STEAMBOAT AIRPARK PRELIMINARY PLAT
LOT 1, WEST ACRES RANCH SUBDIVISION
GLORIA GOSSARD PARKWAY
STEAMBOAT SPRINGS, CO 80487

DRAWING: ROADWAY PROFILE #1

PP12

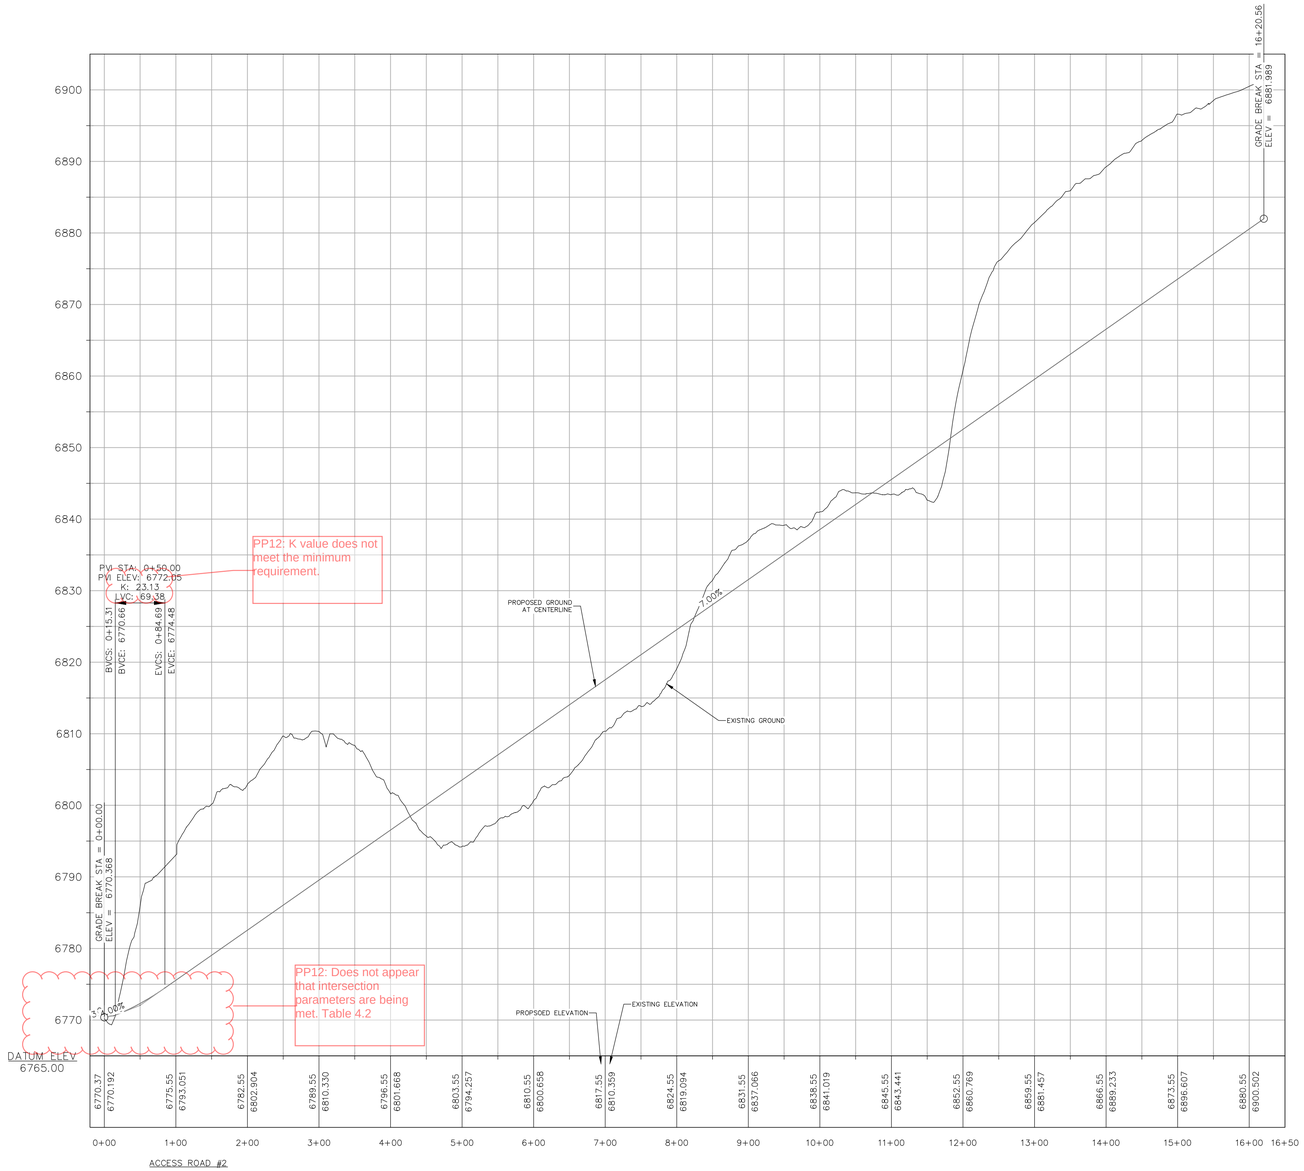
PP12: K value does not meet the minimum requirement.

PP12: Does not appear that intersection parameters are being met. Table 4.2

ACCESS ROAD TYPICAL SECTION
N.T.S.

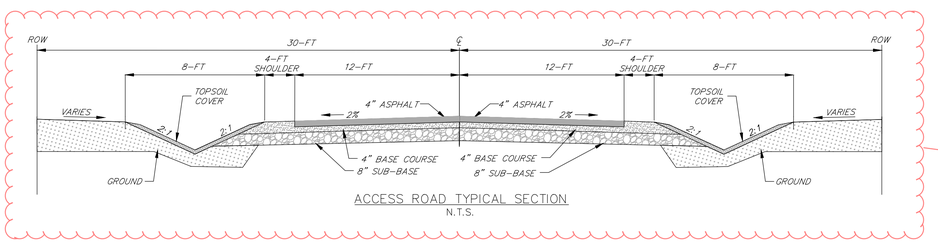
PP12: What typical section is being utilized?
